WWSD Comments

WATERVIEW EAST COMMERCIAL
CONSTRUCTION DOCUMENTS
SANITARY SEWER PLAN AND PROFILE

PROJECT NO.
196195000

C4.6

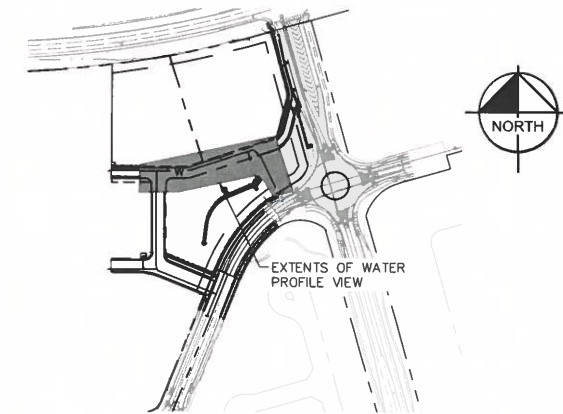
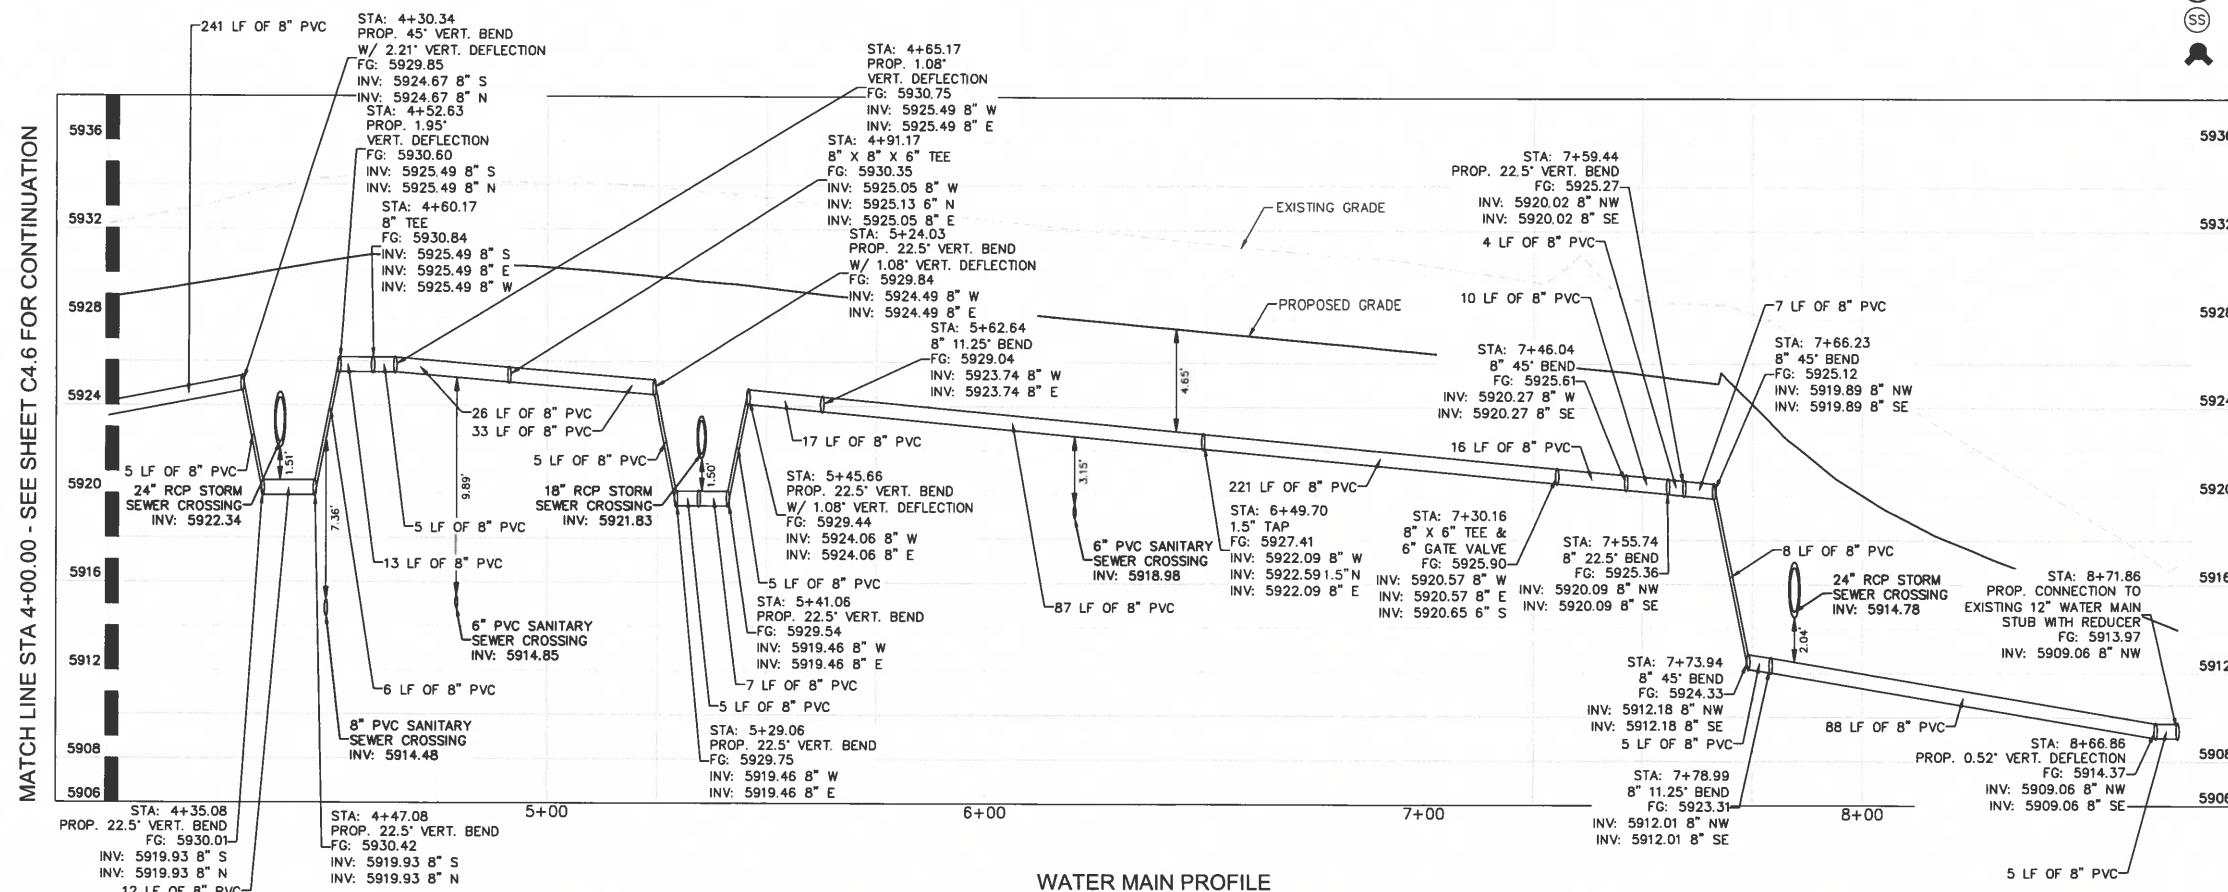
3-8' Valve Plug - 0

STA: 0+700
8" x 12" TEE CONNECTION
FG: 5919.01
Value Cluster
3 x 12"

Valve Cluster

Valve

KH Response:
Tee label updated to include
valve cluster callout.

KH Response:
Gate valve added at proposed
location.

KH Response:
Gate valve added at proposed
location.

KH Response:
Gate valve added at proposed
location.

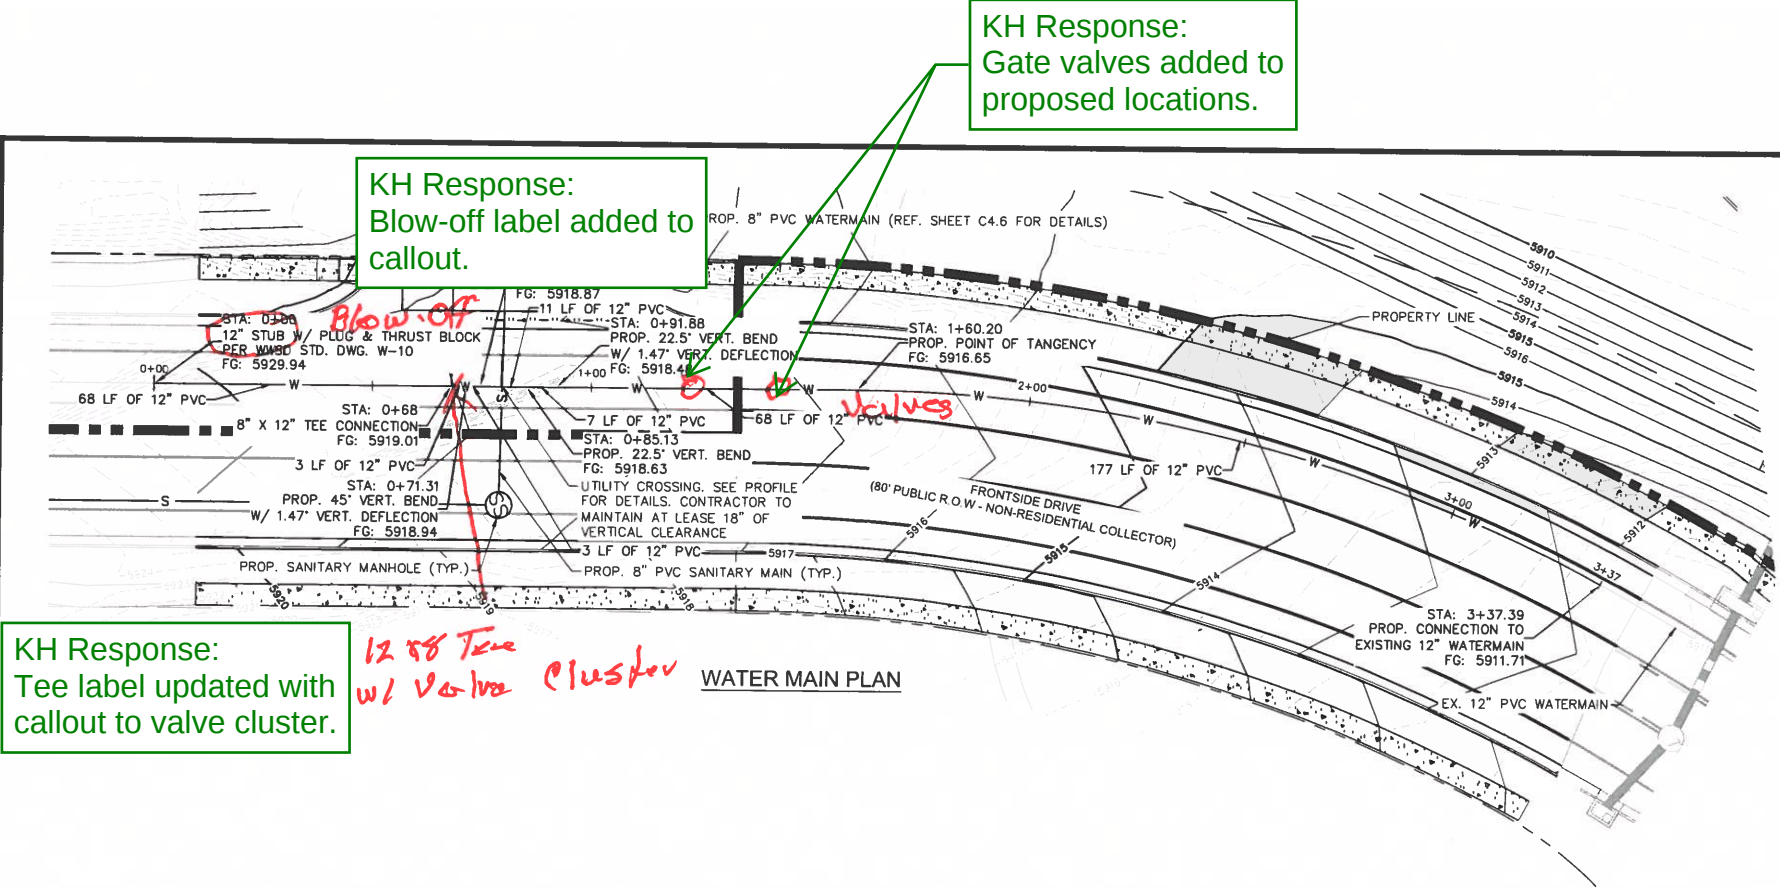
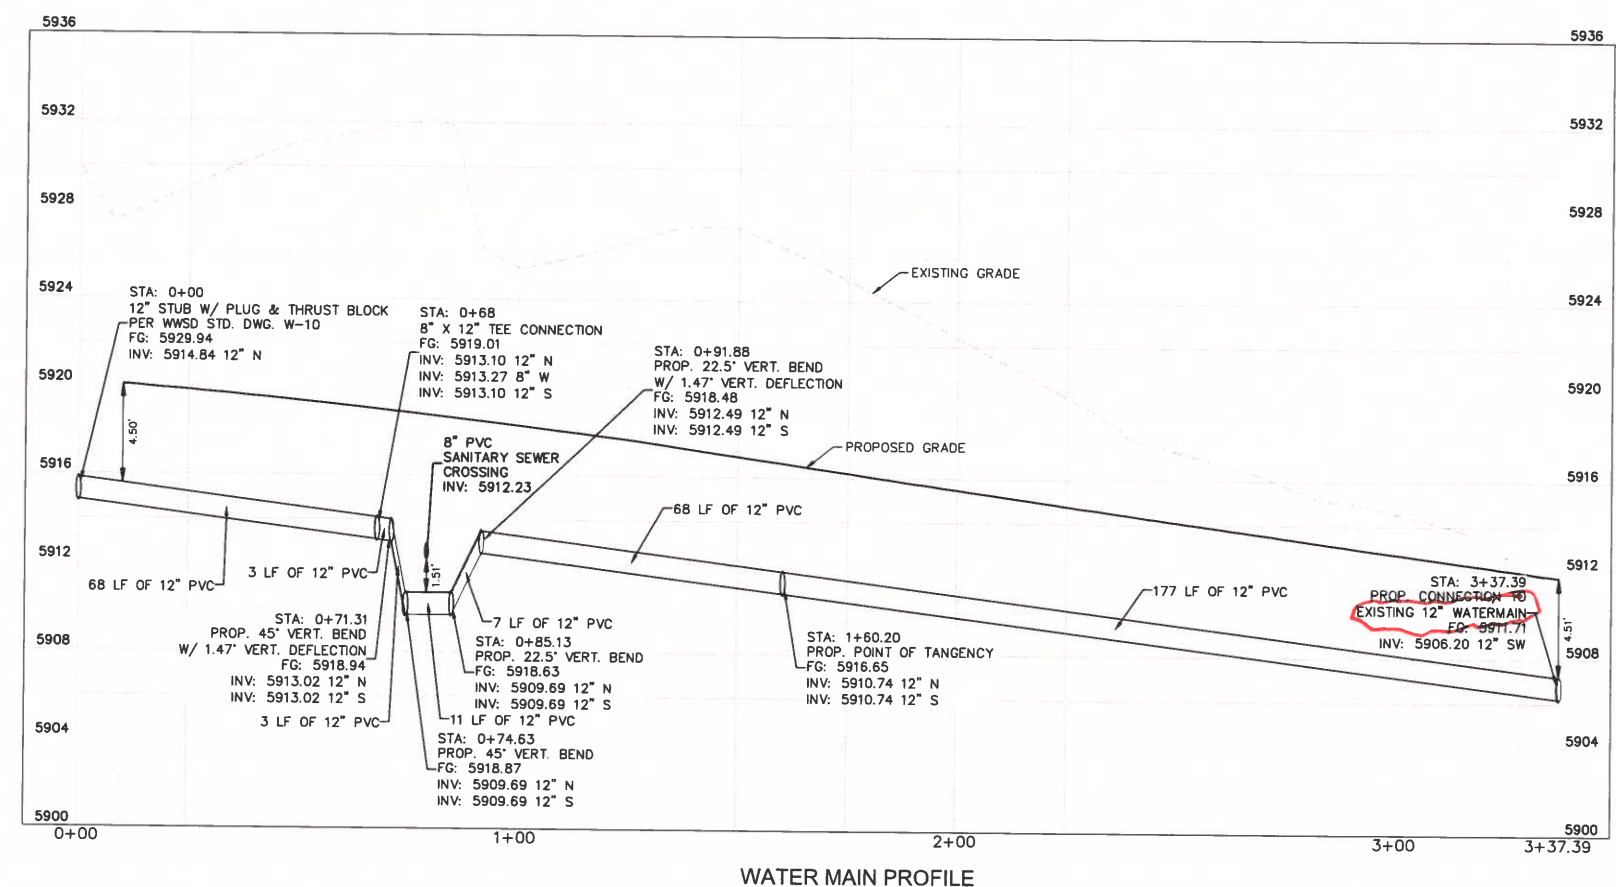
No Existing Water Main

KH Response:
Updated to be called out as future by others.
